RE: Vesting Tentative Tract Map No. 72367-SL-2A
Adresse: 2925 West Waverly Drive
Hollywood Planning Area
Zone : RD1.5-1XL-RIO
D. M. : 151-5A207
C. D. : 4 - Ryu
CEQA : ENV-2013-1998-MND-REC1

LETTER OF CLARIFICATION

REVISED

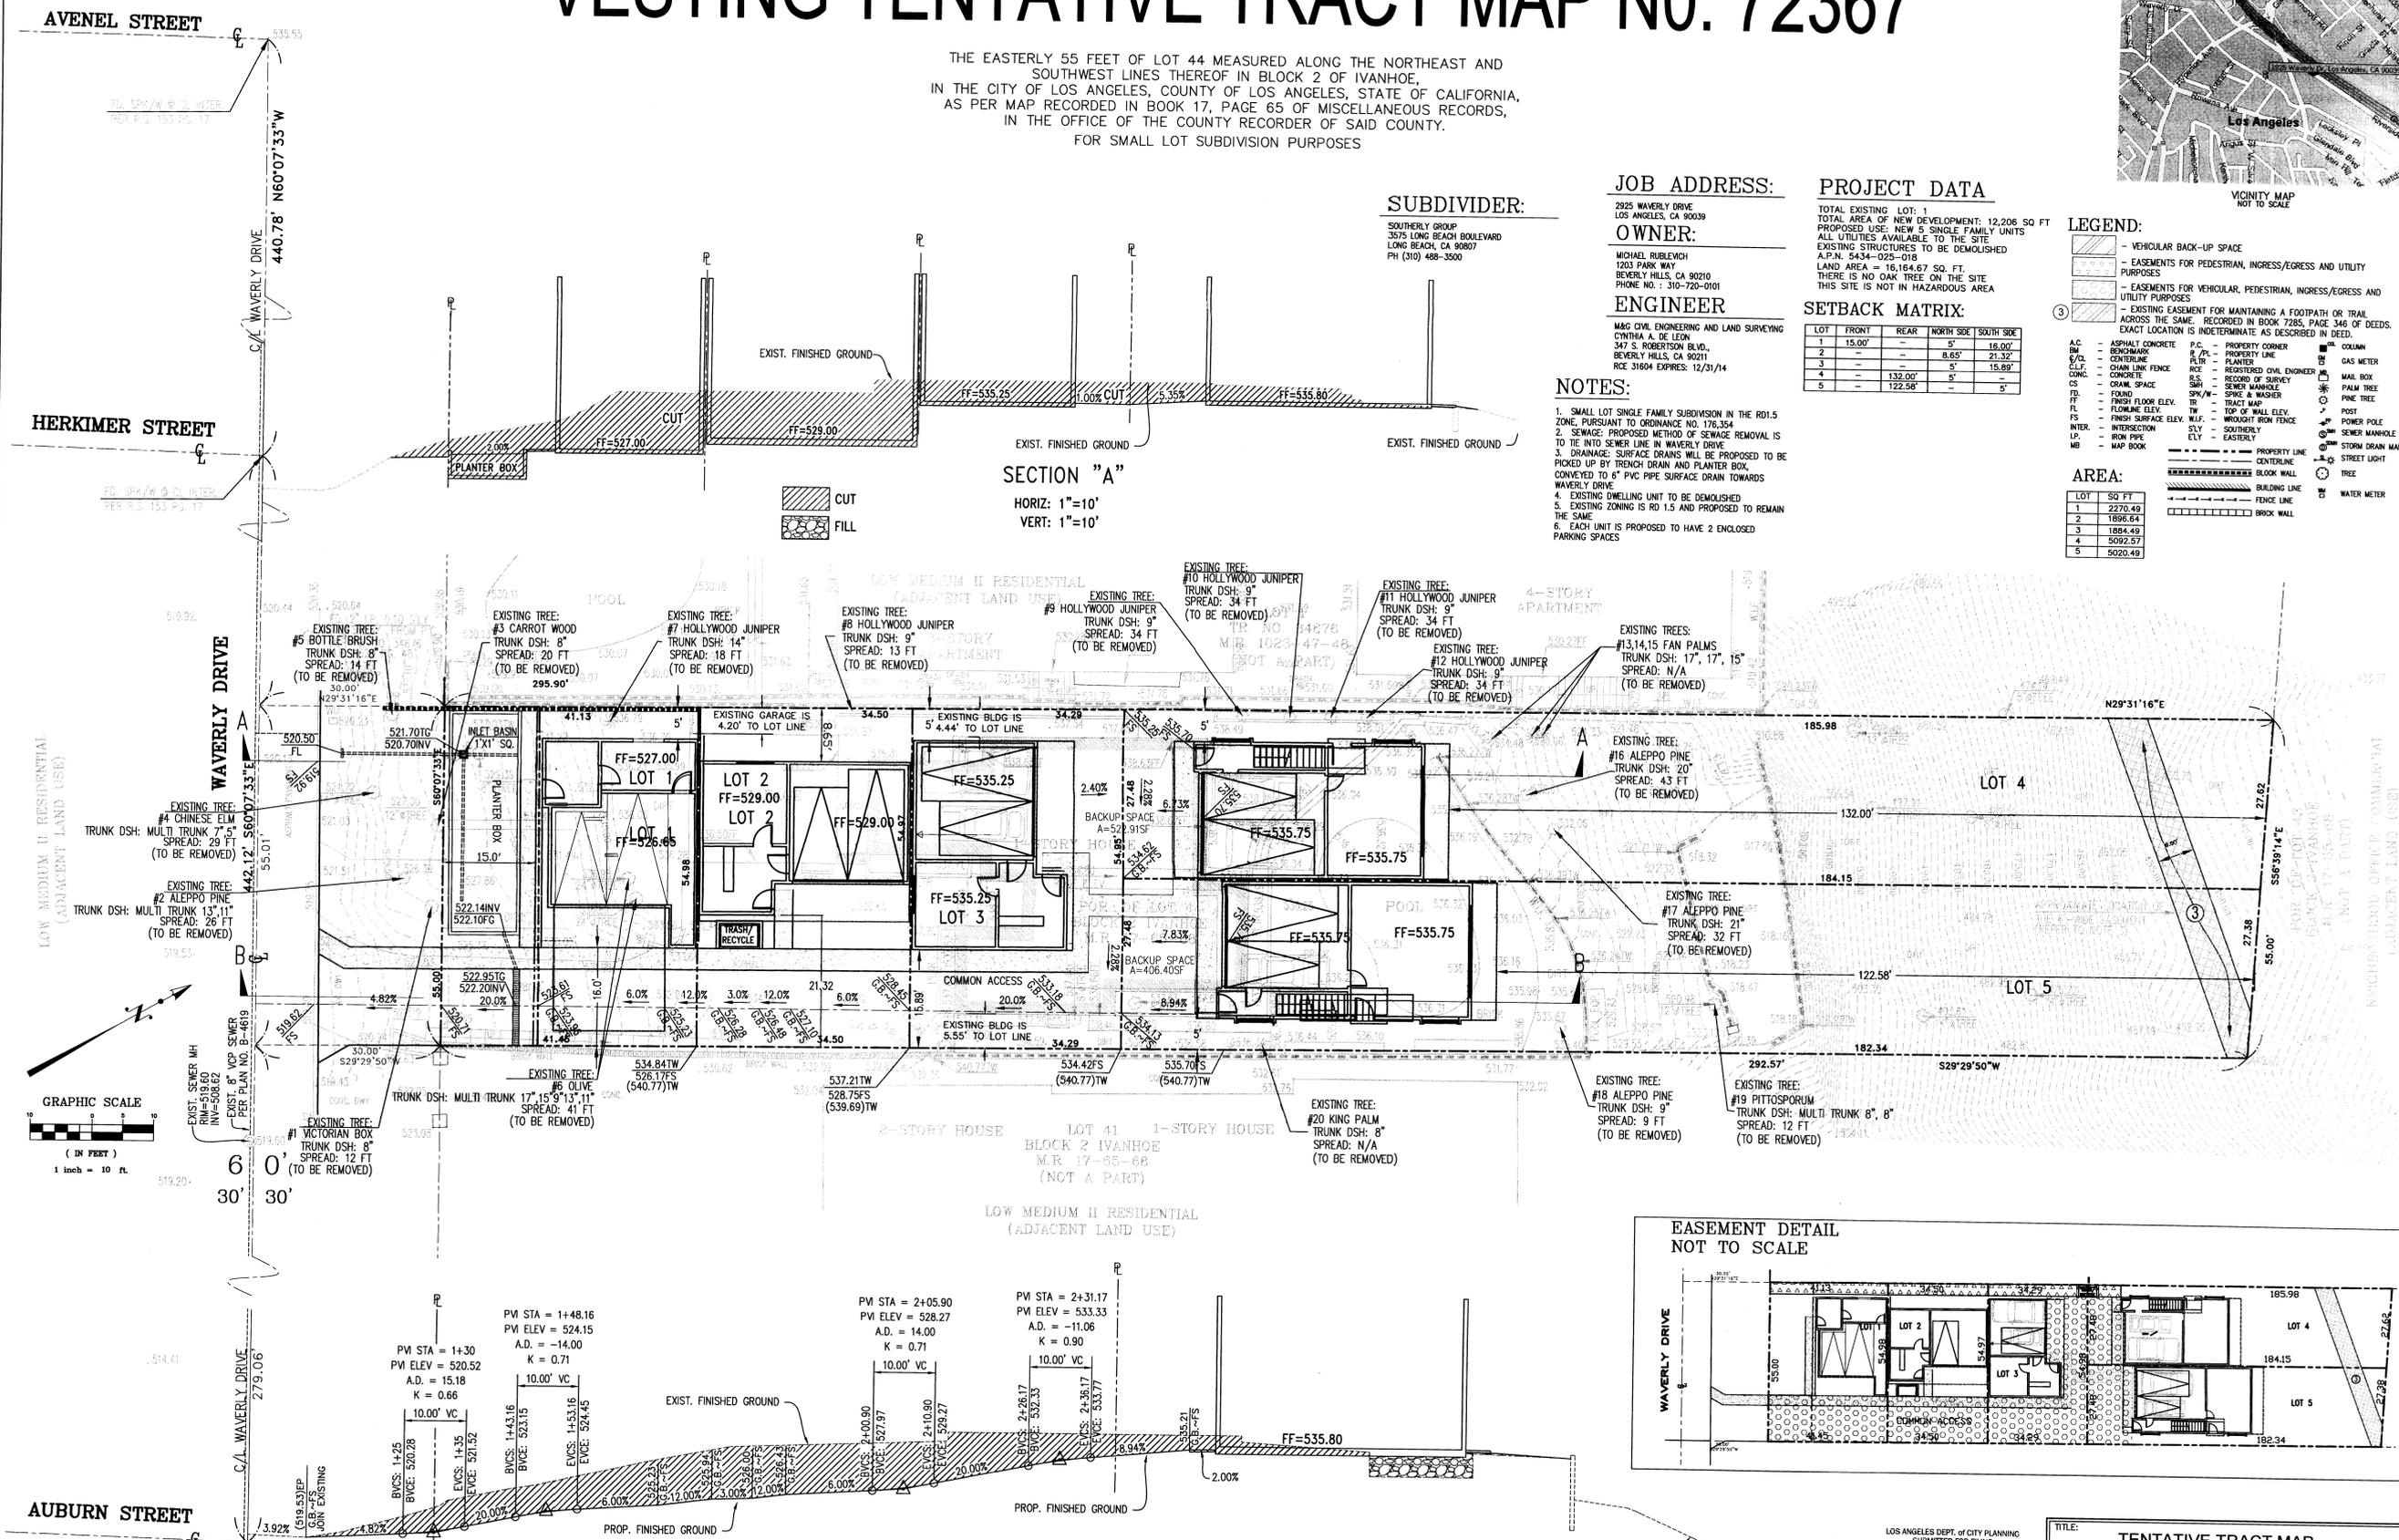
On February 10, 2020, the representative for the new owner of the property requested clarification regarding the setback matrix identified on the approved tract map stamped dated December 11, 2014, the setback matrix indicated in the Condition No. 16 (1) of the Letter of Determination dated January 12, 2016, and has requested minor changes to the setbacks which were approved.

In reviewing the setback matrix shown on tract map stamp dated December 11, 2014 and the setback matrix indicated in Condition No. 16 (1), there was a typographical error in the labeling of the columns of the setback matrix in the Letter of Determination. Additionally, the setback matrix in the Letter of Determination included the dimensions for the separation between the proposed buildings in the instance that the approved map did not include the dimension.

The applicant submitted a site plan dated January 6, 2020, which indicated minor revisions to the setback matrix. In reviewing the revised map, the revisions are minor in nature and do not substantially change the project from what was previously approved. Additionally, the revisions do not reduce the minimum required five-foot setback from the perimeter of the subdivision. On February 13, 2020, the Deputy Advisory Agency requested that a revised tract map be submitted with the revised setback matrix, while maintaining the same orientation of the yard designations as originally shown on the approved tract map and determination letter.

It is hereby clarified that the site plan and final tract map shall be in substantial conformance with the revised tract map stamp-dated February 18, 2020, in lieu of the map stamp-dated December 11, 2014 and all other terms and Conditions of VTT-72367-2A shall remain as originally granted, except as follows:
